Draft Value Study Report

The Dalles AWSBS Debris Management Project

**Columbia River Basin, The Dalles, Oregon
Portland District**

Draft Report Date: 10 September 2021

AWSBS with Level Transmitters

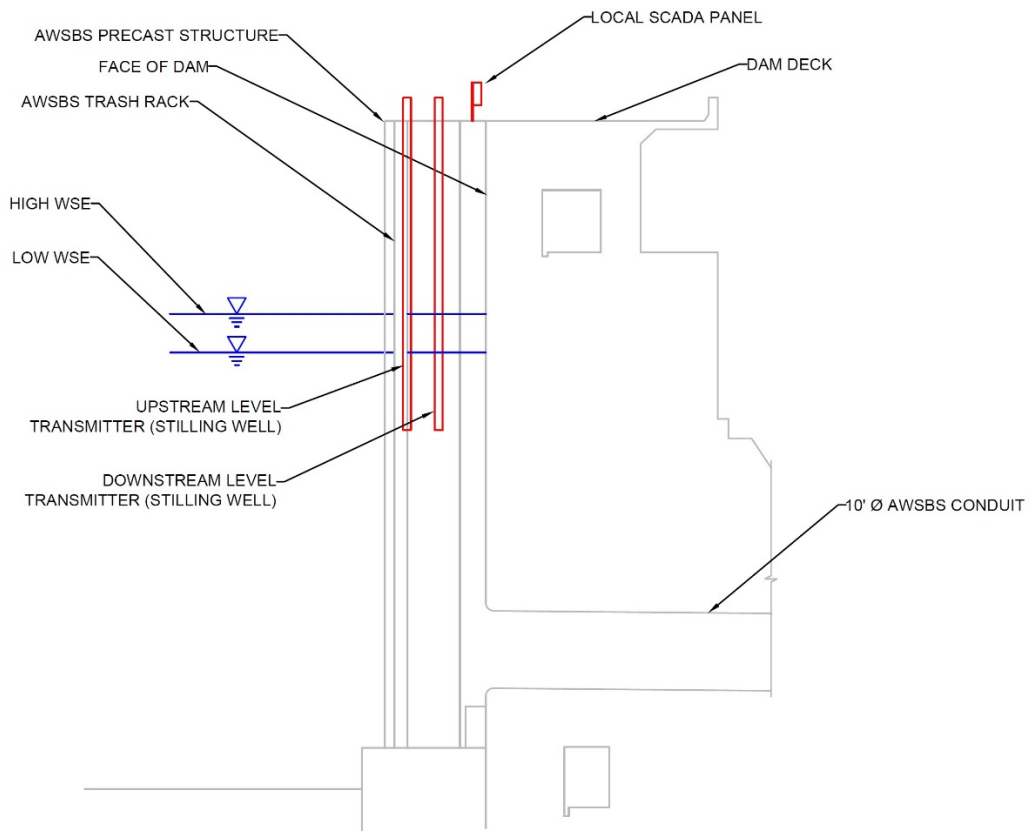
Review Comments: It was noted that, while this proposal was well received, a delay would occur in deciphering shutdown times for the valves; the delay time would be calculated through learned experience.

East Fish Ladder Entrances at The Dalles Dam

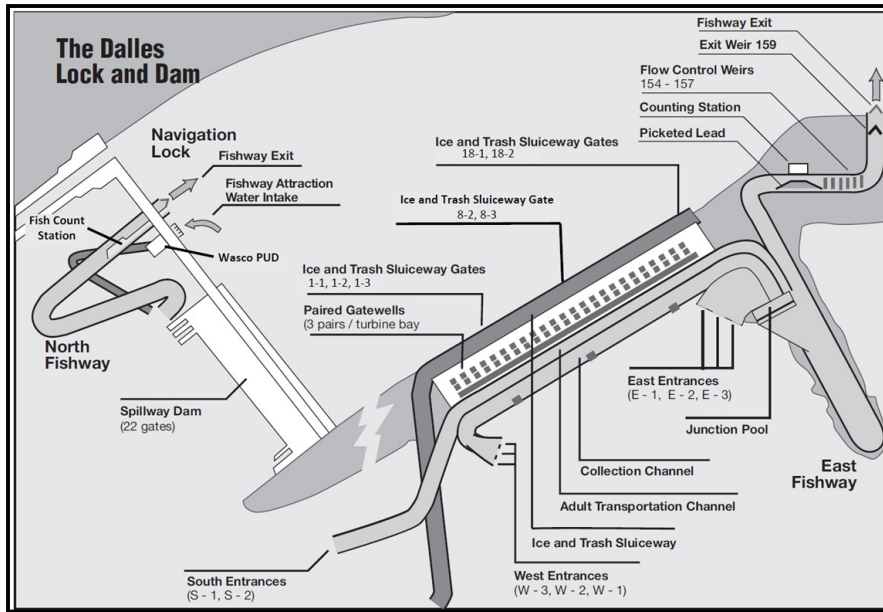
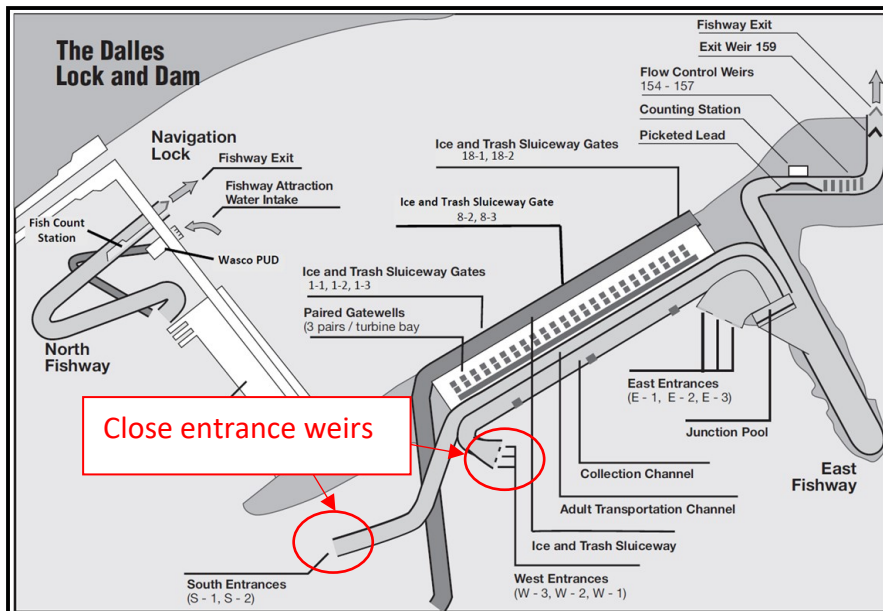
Review Comments: As it stands, it is required that two of the three entrances on the east/west and both on the south, remain open. There is potential for the southern entrance to be partially closed.

HD: We already recommend a closure of one of the 15-ft wide south entrance gates during a combined AWSBS and single FU operation. Otherwise the system will be operating in full criteria.

AWSBS with Backwash System

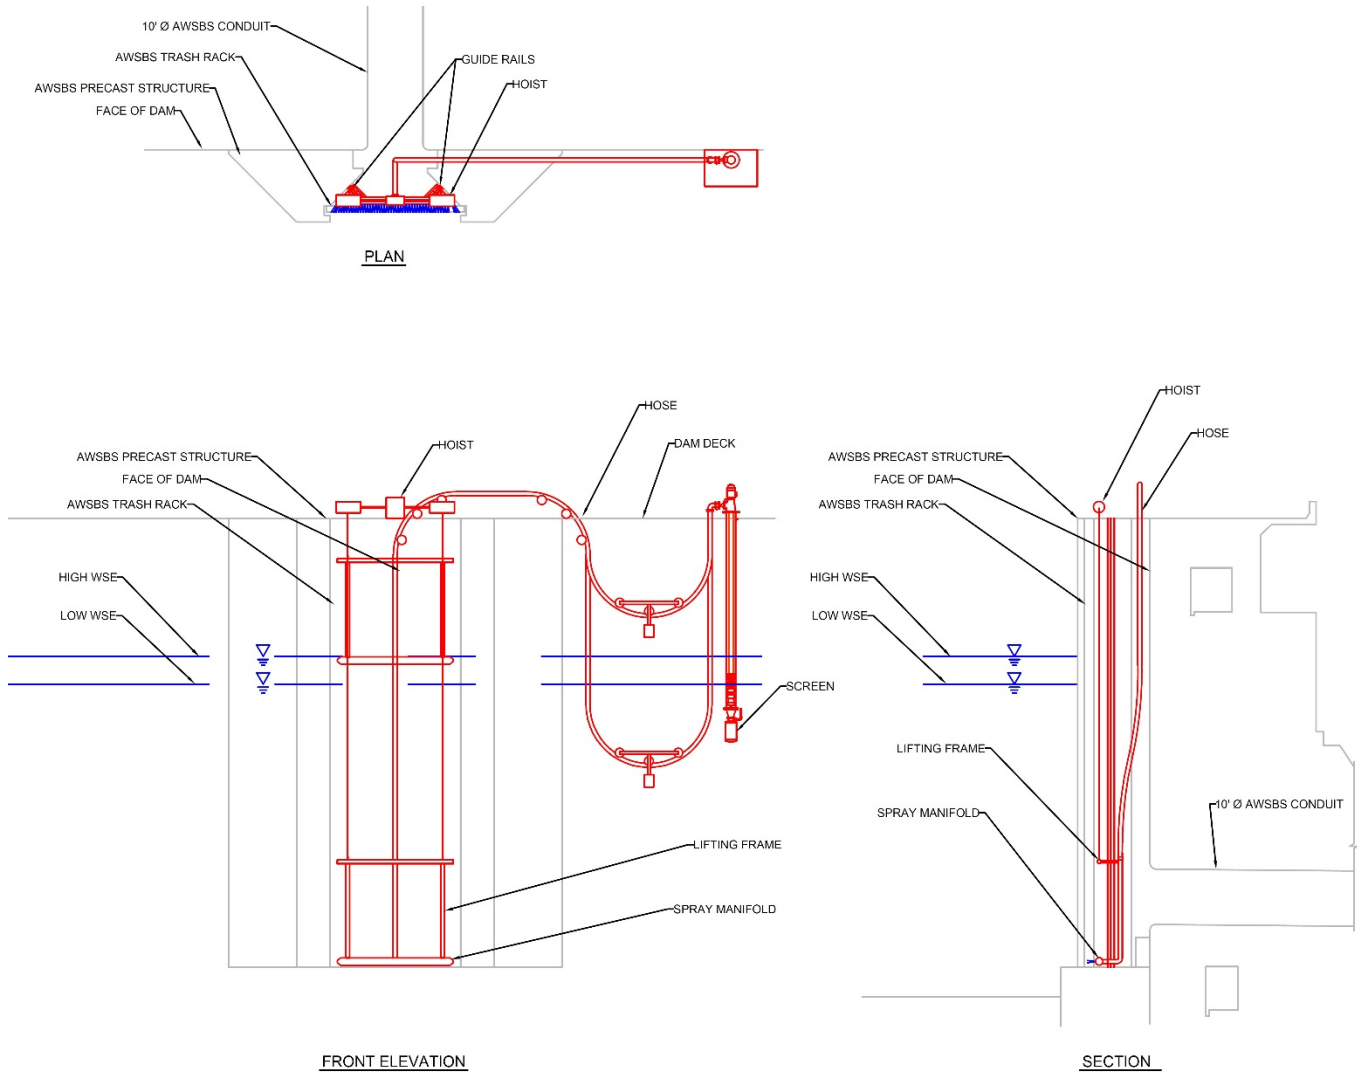
Discussion: This proposal is based on a design concept that has been used to successfully clean fish screens on several large surface fish collectors used for the passage of downstream migratory fish. The basic design uses a line of orifices spaced along a manifold which result in a linear series of jets that spray from the back of the screen out through the screen face. The jets are spaced such that as the submerged jets expand, they effectively merge into one long linear jet that provide continuous coverage over the entire width. Implementing this cleaning system on the trashrack would provide an effective cleaning system that could be operated while the AWSBS is running and be capable of cleaning the trashrack once every seven minutes. A normal cleaning cycle would result in two passes of the jet through the trashrack. Sketches of the existing AWSBS intake and the proposed backwash cleaning system are depicted following this discussion.
